Independent Review of

"Control Rod Insertion Following a Cold Leg LBLOCA, D.C. Cook, Units 1 and 2"

D. A. Prelewicz
SCIENTECH, Inc.
Rockville, Maryland

Boron Concentration vs Time

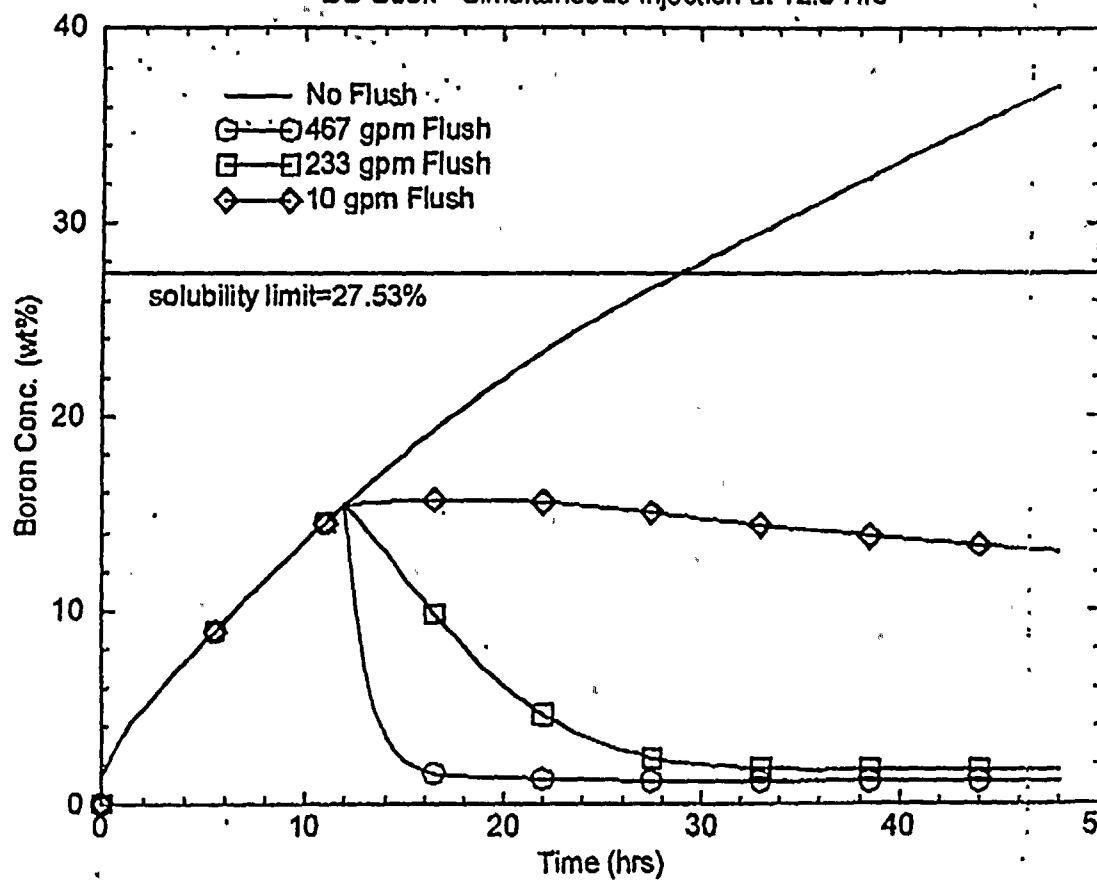
The attached figure presents the boron concentration versus time following a large break LOCA where reactor coolant system pressure remains near atmospheric pressure. The figure shows the boric acid content as a function of time with no flushing flow assumed and indicates that about 30 hours is available for the operators to initiate simultaneous injection. The solubility limit at 14.7 psia indicated in the figure is 27.53 wt%. Since the safety injection system provides sufficient flow to maintain the core covered with two-phase following reflood of the core, the rate at which the boron builds up is a function of the decay heat generation rate. Any additional injection into the cold side is merely spilled through the break. The equation solved to compute the boron concentration under these conditions is (please see the nomenclature section for identification of the symbols):

During the long term, the operators will need only a single high pressure pump to cool and control the boric acid build-up in the core. To show the effect of the net core or flushing flow, it was assumed that the operators switch to simultaneous injection at 12 hours into the event. The effect of several flushing flow rates is demonstrated in the attached figure where injection flows of 467, 233, and 10 gpm were assumed. These flushing flow rates maintain the long term boron concentrations at the values of 1.15, 1.73, and 12.9 wt% (i.e. 2001, 3017, and 22,680 ppm), respectively. Flushing flows associated with the 467 gpm injection rate therefore produce boron concentrations above the sump or source concentration at the time simultaneous injection is initiated. However, these analyses show that for a wide range of ECC injection rates, the concentration can be maintained well above the re-criticality condition of 1500ppm.

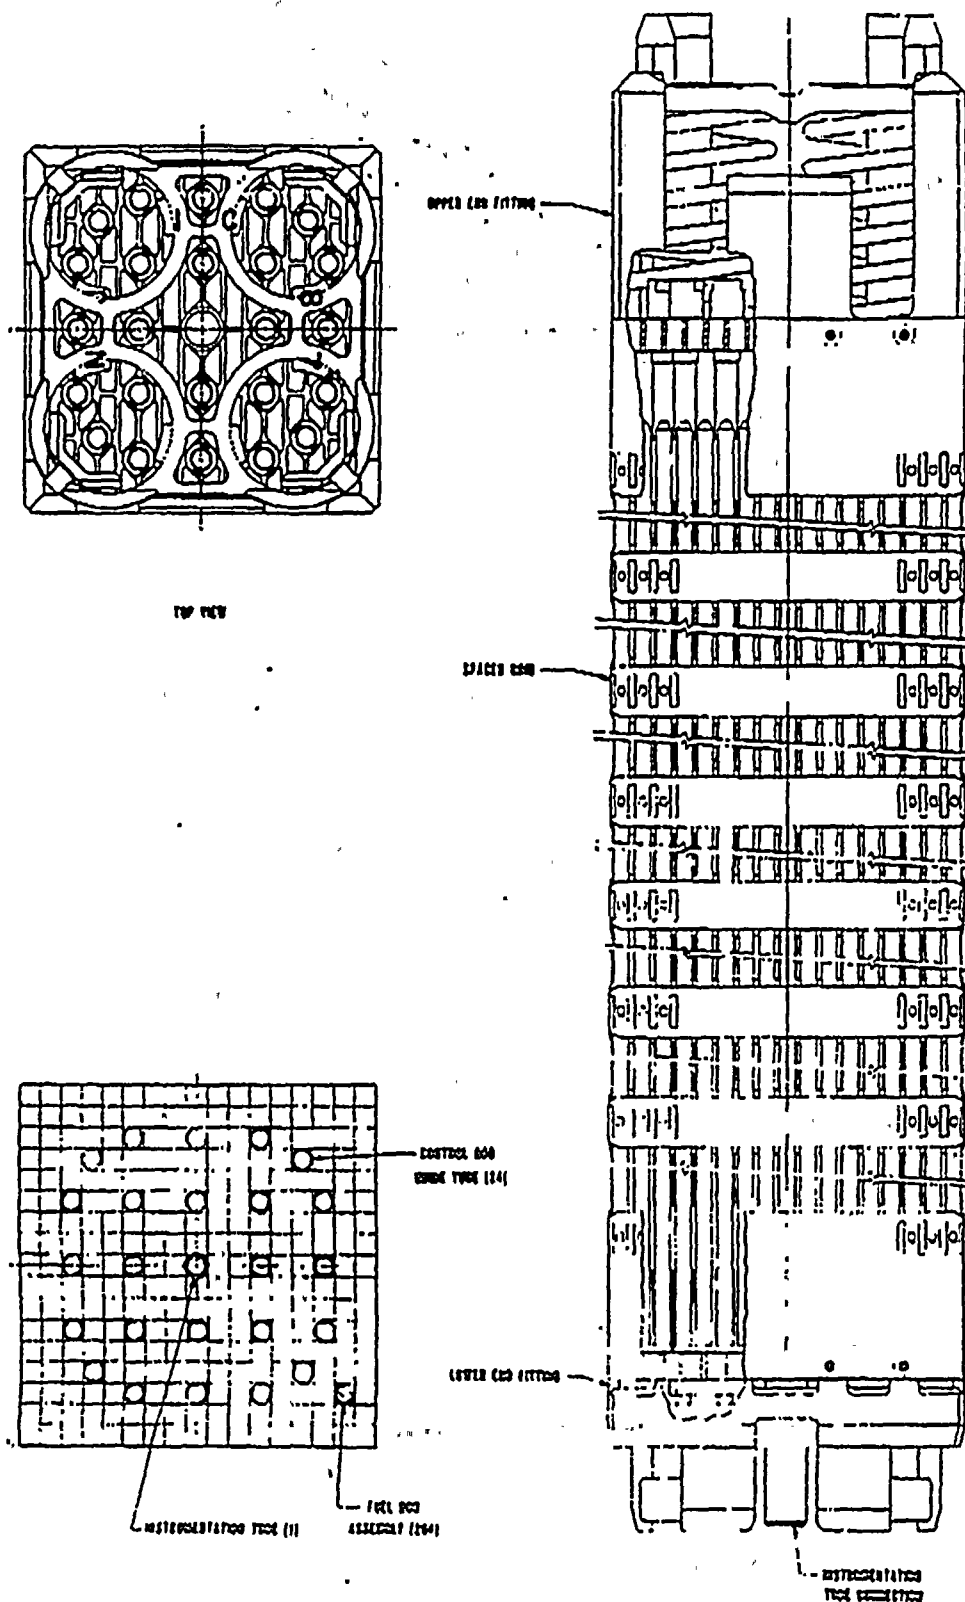
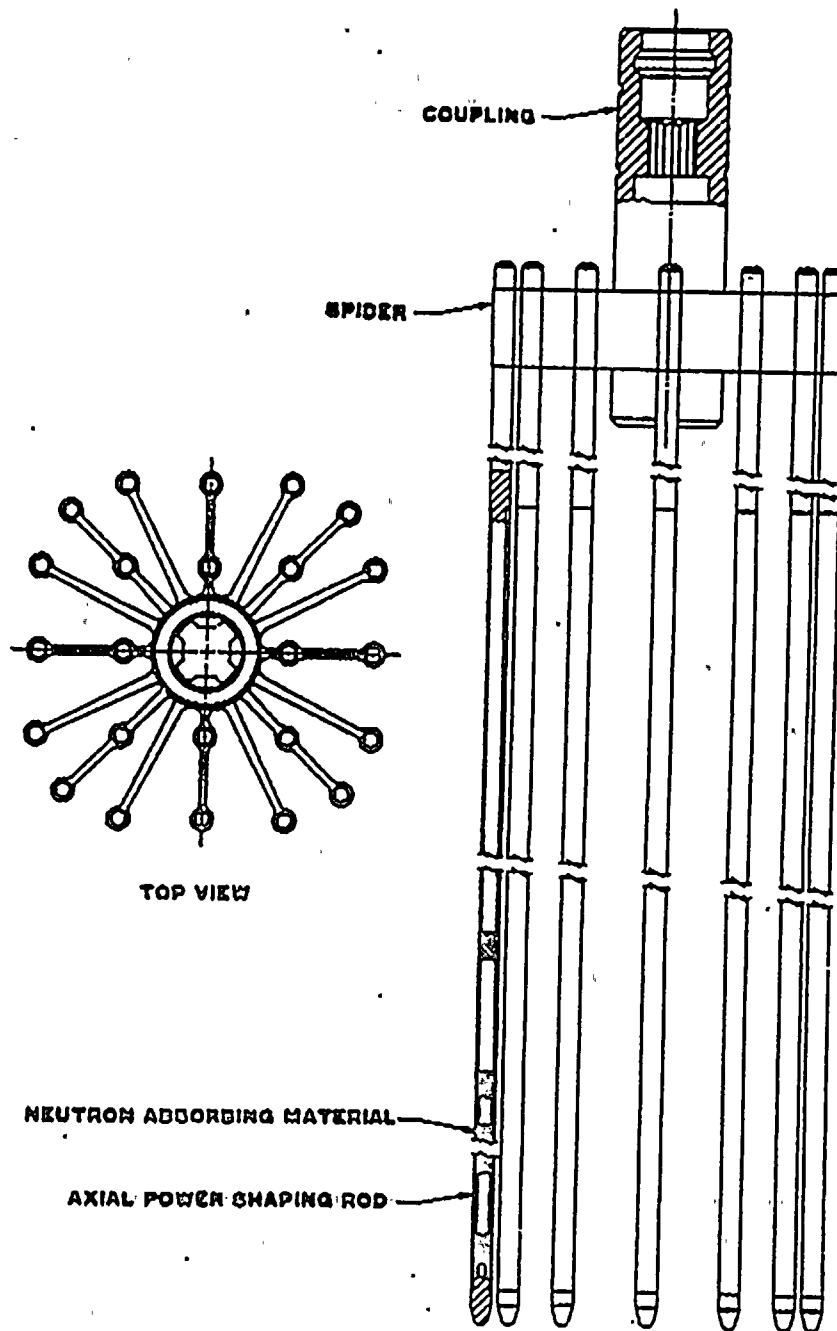
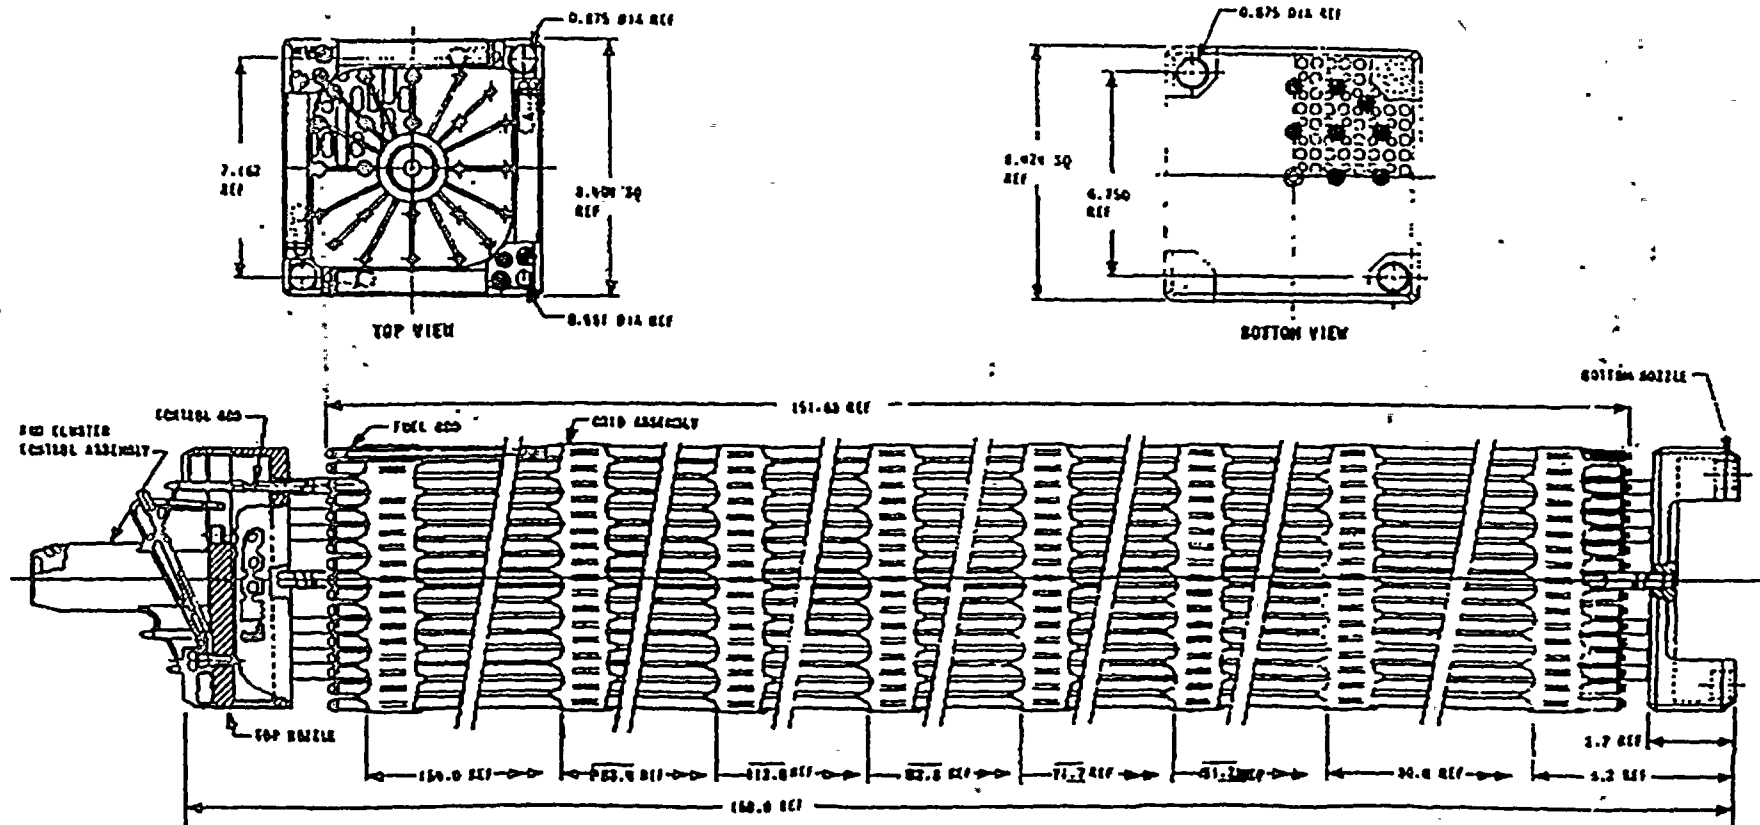
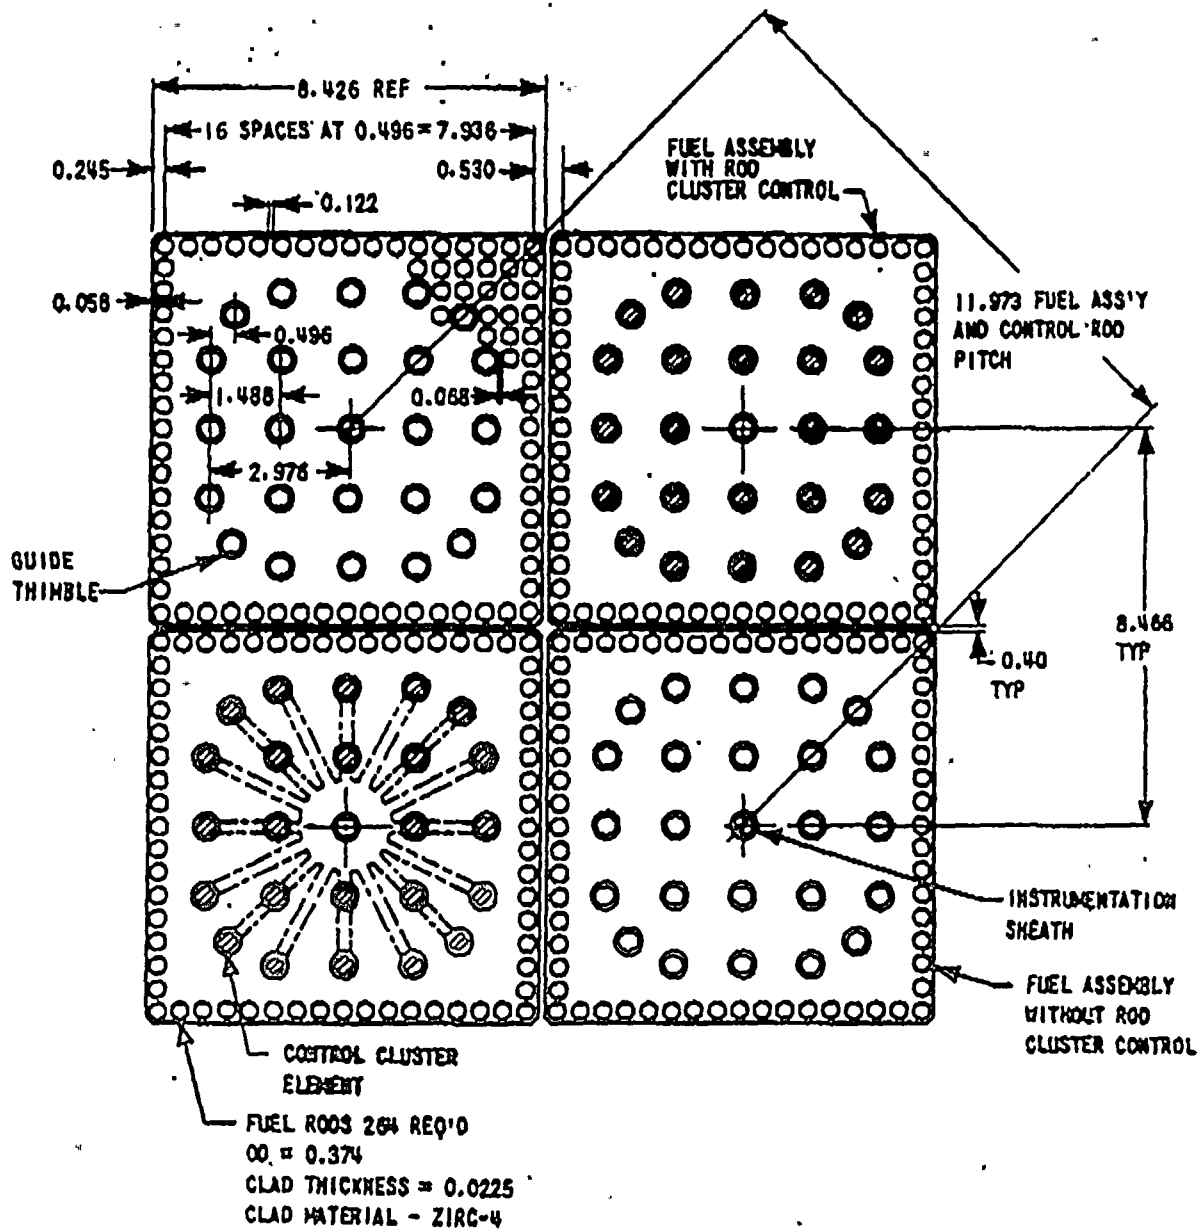
The B&W 17x17 fuel assembly is shown in Figs. 1 and 2 while the Westinghouse 17x17 fuel bundle is presented in Figs. 3 and 4. As demonstrated in the figures, both bundle designs are identical. Both bundle designs are 12 feet in length, contain eight spacer grids, and utilize a 24 finger control rod cluster. As such, the mechanical behavior of both bundles is expected to be similar so that the Westinghouse load evaluation can be concluded to also reflect the expected behavior of the B&W bundle design.
